I, Robert M. Oberdorfer, RLA, hereby certify that this project was constructed in general conformance with the approved plans and specifications. "As-built" information shown hereon reflects changes made during the course of the project, and is based upon change order records and information provided by the City of Albuquerque Public Works Department field inspector. No as-built information was provided by the contractor.

CONSTRUCTION PLANS FOR RIVERVIEW TRAIL

Golf Course Road to Rancho Solano Court

STA. 20+00 TO STA. 25+00
PLAN AND PROFILE

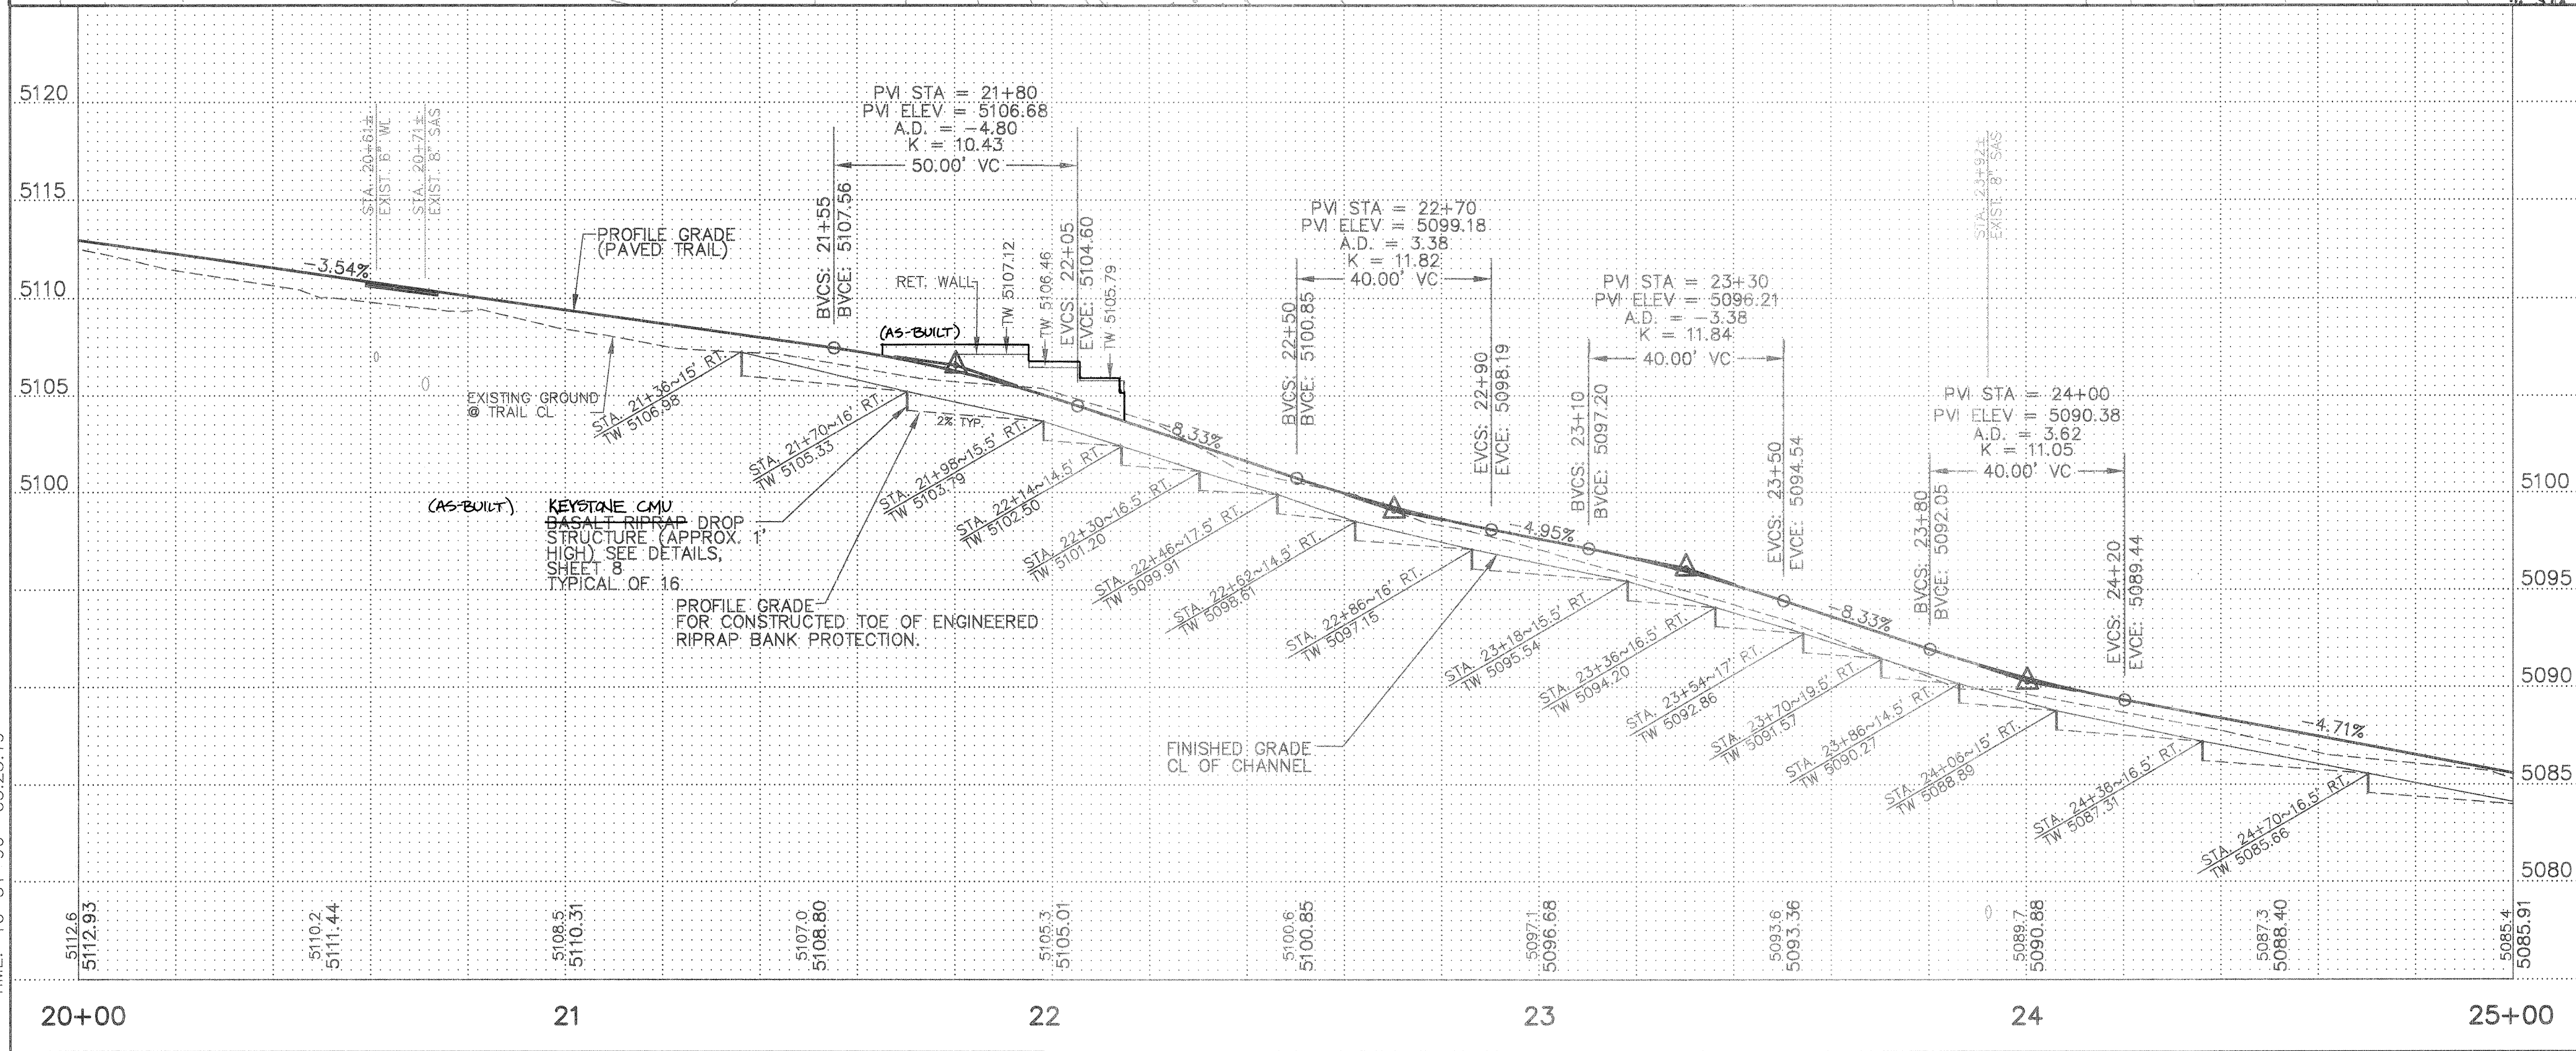
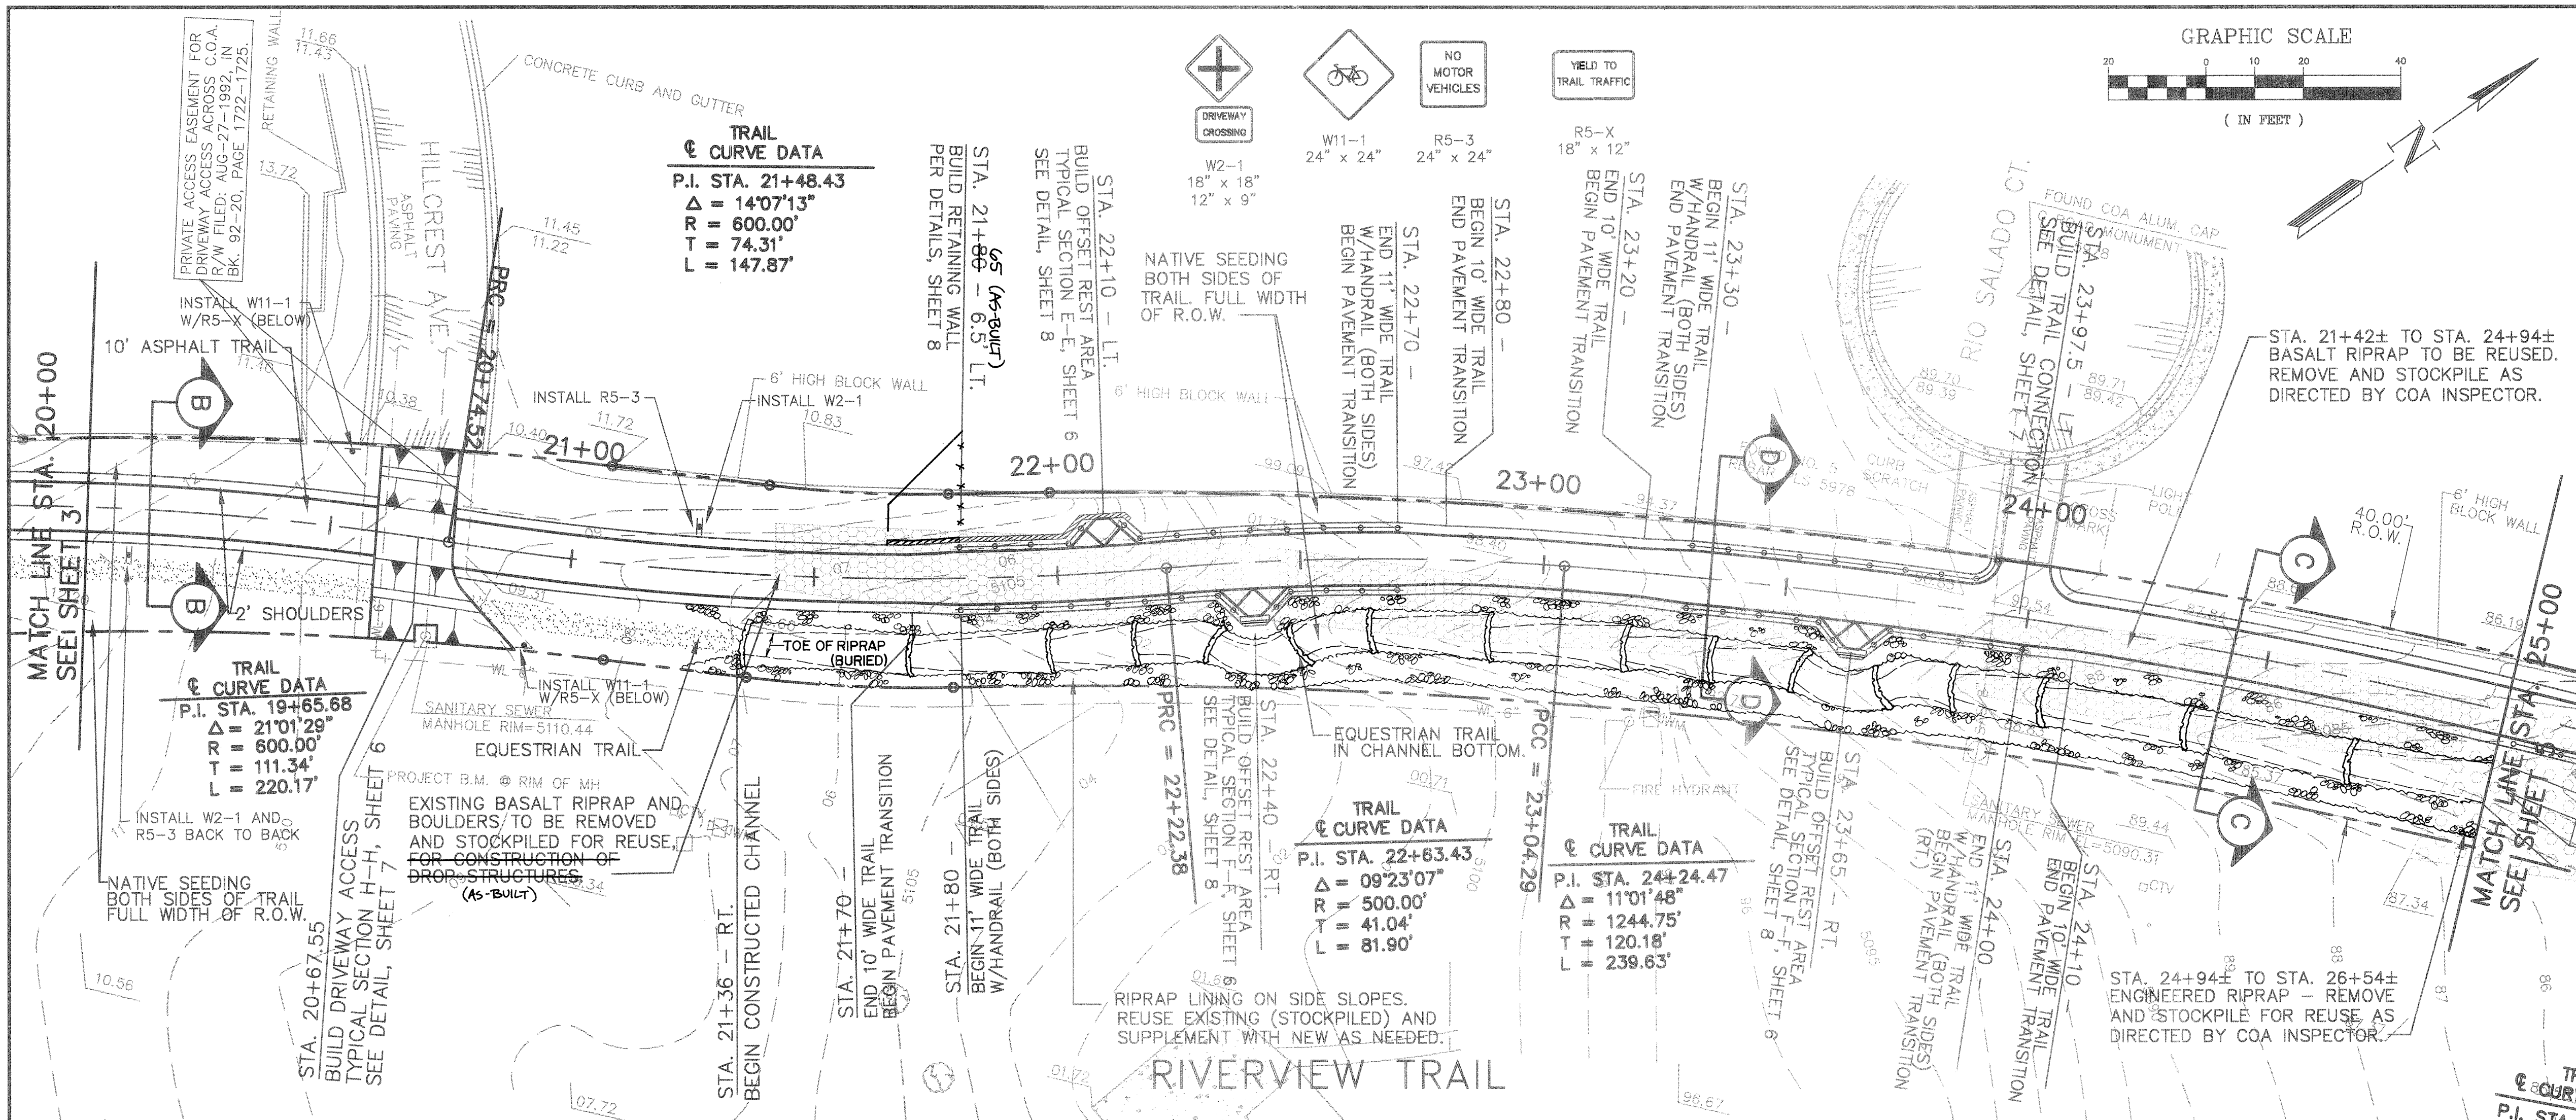
1. FOR TYPICAL SECTIONS, SEE SHEET 6.
 2. ENGINEERED RIPRAP AND BASALT RIPRAP TO BE STOCKPILED SEPARATELY. ENGINEERED RIPRAP TO BE REUSED AS CHANNEL SIDE SLOPE AND DESILTING BASIN LINING (SUPPLEMENT WITH NEW AS NECESSARY). ~~BASALT RIPRAP TO BE USED~~ FOR CONSTRUCTION OF DROP STRUCTURES (SEE DETAILS, SHEET 8). ANY REMAINING BASALT RIPRAP SHALL BE PLACED ON STEEPENED SLOPE WEST OF TRAIL BETWEEN STA. 21+00 AND STA. 22+50, AT DIRECTION OF LANDSCAPE ARCHITECT.

- (INSTALLED BENCHES: VICTOR-STANLEY MODEL 8, WITH RECYCLED PLASTIC TIMBER SLATS AND ARMRESTS)
